Kansas Department of Agriculture
Division of Water Resources
 APPROVAL OF CHANGE APPLICATION WORKSHEET

RE: Filed Office Application for Change
Water Right, File No. 2309

DWR FIELD OFFICE APPLICATION FOR APPROVAL TO CHANGE THE PLACE OF USE AND/OR THE POINT OF DIVERSION

This evaluation of proposed change in point of diversion, File No. 2309

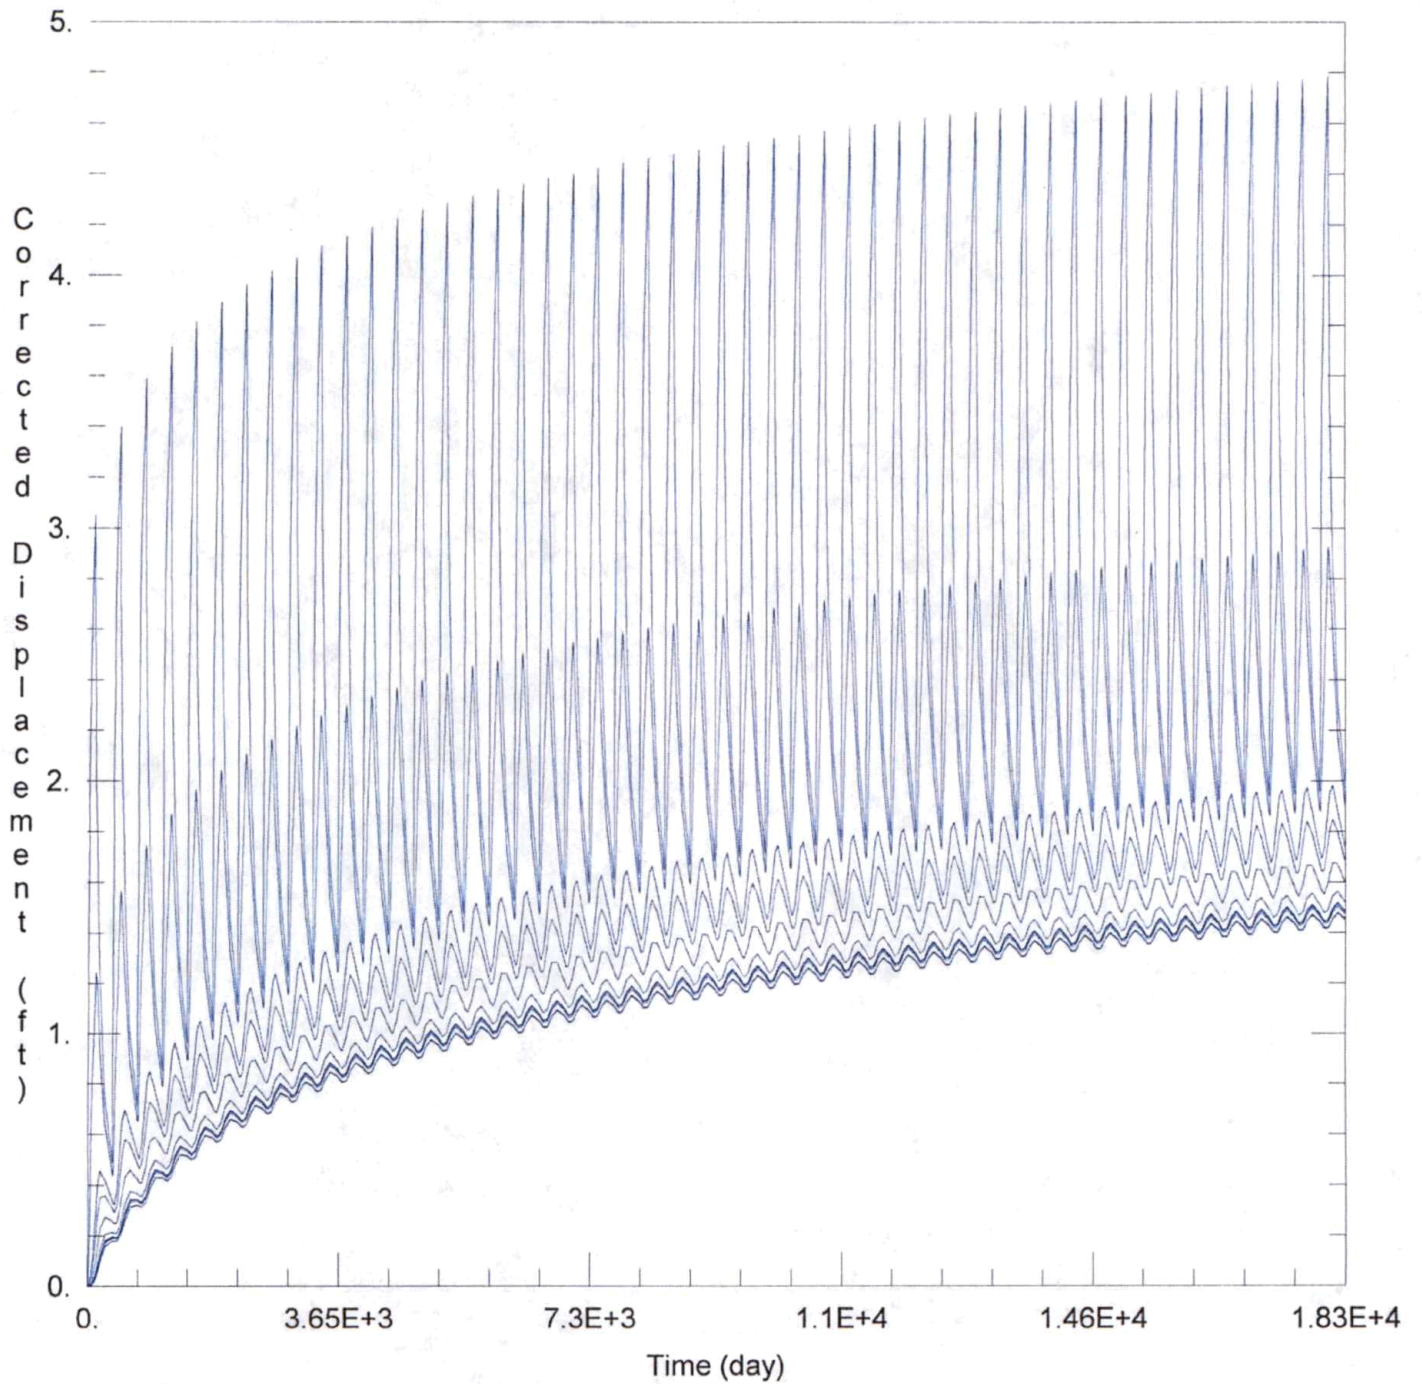
Economic Drawdown Constraint (EDC) = 0.4 * 72 ft = 28.3 ft

Physical Drawdown Constraint (PDC) = 72 ft – 20 ft = 52.0 ft

The proposed move is in a depleted aquifer area with about 60-80 ft of remaining saturated thickness. The proposed well will be drilled well below this depth, but the driller's log does not show much good aquifer material. The analysis shows that net well-to-well effects created by this proposal are likely to be large, but it should be noted that the actual rate and quantity pumped from the well location will likely be far less than the proposed rate of 1200 gpm and quantity of 1057.6 AF. No well within a mile of the proposed well site has been observed pumping more than 500 gpm in recent years, and several neighboring wells are no longer operating due to insufficient water. Concerned neighbors should contact GMD3 at (620) 275-7147 or the Division of Water Resources at (620) 276-2901.
